DOE/EA-1696

**ENVIRONMENTAL ASSESSMENT FOR THE
PROPOSED PANTEX RENEWABLE ENERGY PROJECT**

PANTEX PLANT * AMARILLO, TEXAS * July 2010

Estimated Occupied Range of the Lesser Prairie Chicken
Pantex Renewable Energy Project
Carson County

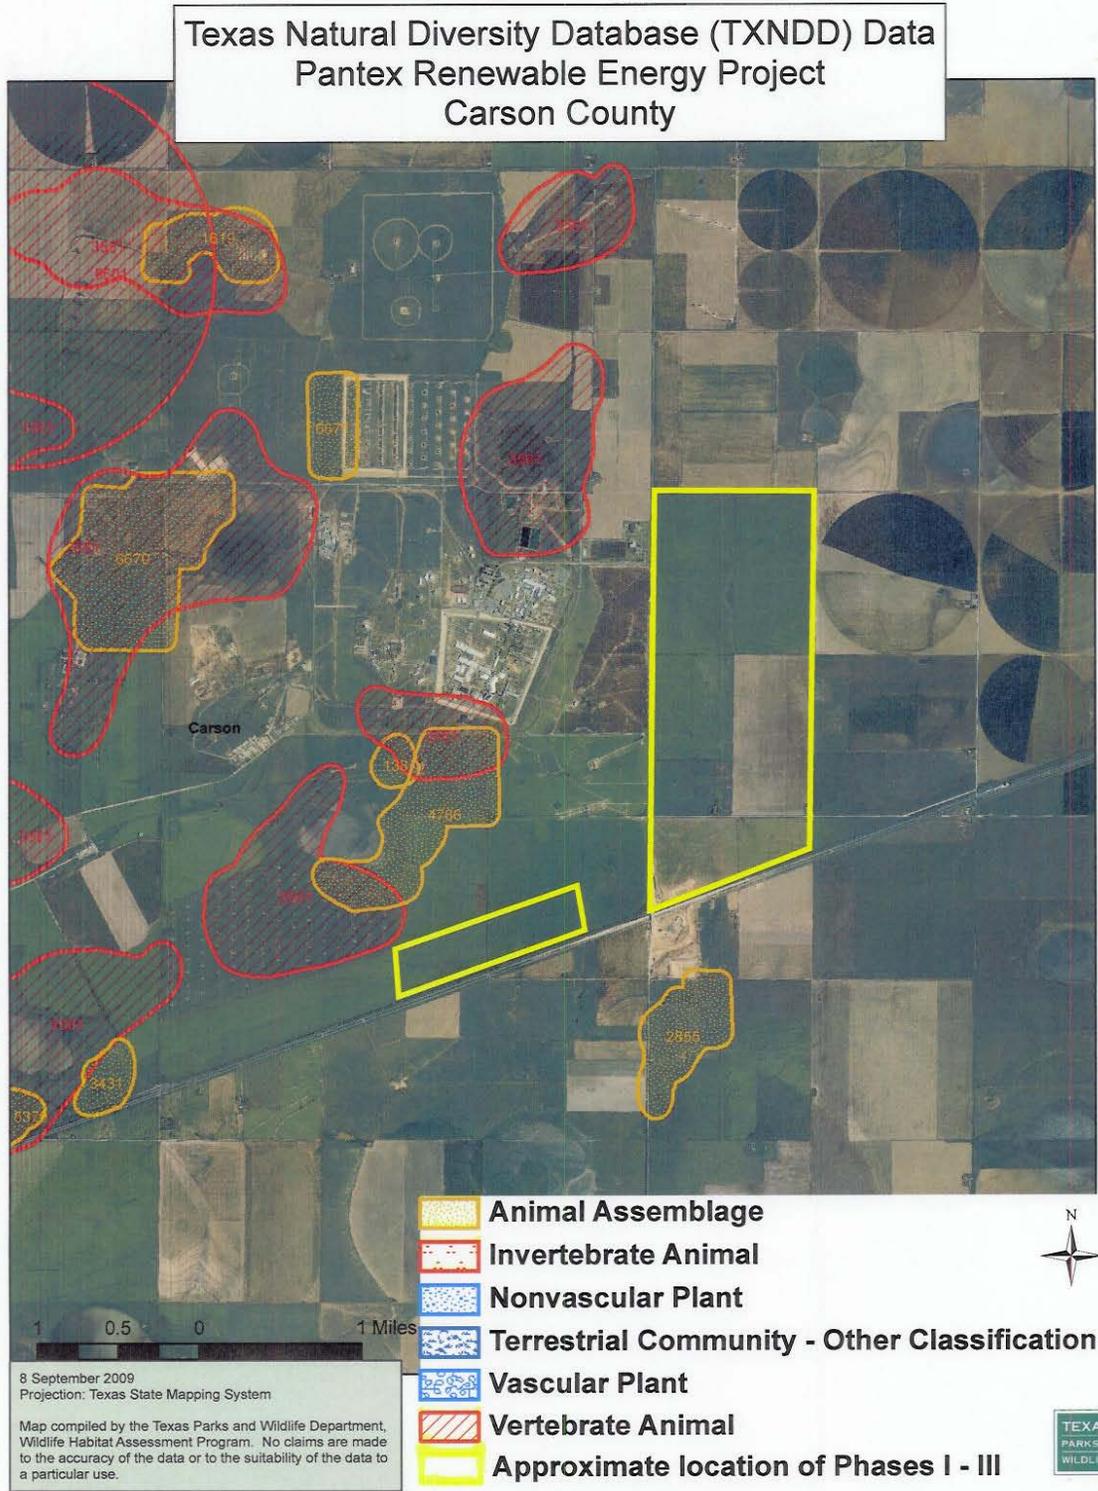
The Service also has concerns regarding impacts to the lesser prairie-chicken (*Tympanuchus pallidicinctus* [LPCD]. Candidate species, such as the LPC, are not afforded federal protection under the ESA; however, we recommend that potential impacts to these species be considered during project planning. Our records indicate that suitable LPC habitat lies adjacent to the east side of the PREP proposed project location. Preliminary research conducted in similar habitat in southwestern Kansas has shown that the LPC demonstrates some avoidance of tall, vertical structures (Pitman *et al.* 2005); however, definitive research showing avoidance of wind turbine facilities does not exist at this time. Also, encroachment and fragmentation of LPC habitat by wind farms may give the non-native, ring-necked pheasant (*Phasianus colchicus*) a competitive advantage over the LPC (Hagen *et al.* 2007). Ring-necked pheasants are more tolerant of habitat fragmentation and anthropogenic landscape characters (Hagen *et al.* 2007) and are known to increase prairie-chicken nest competition and parasitism in fragmented habitats (Hagen *et al.* 2002, Westemeier *et al.* 1998). An overview of the potential effects of wind energy projects on the LPC is presented by Pruett *et al.* (2009).

Pantex is striving to keep wind turbines and associated infrastructure out of areas of prairie dog colonies, shortgrass prairie, and away from playas. All planned turbines are slated for areas currently in cultivation. Electrical transmission lines will be buried within the wind farms and raptor protection will be installed on connecting on-site powerline types that are of a design that pose a threat of electrocution.
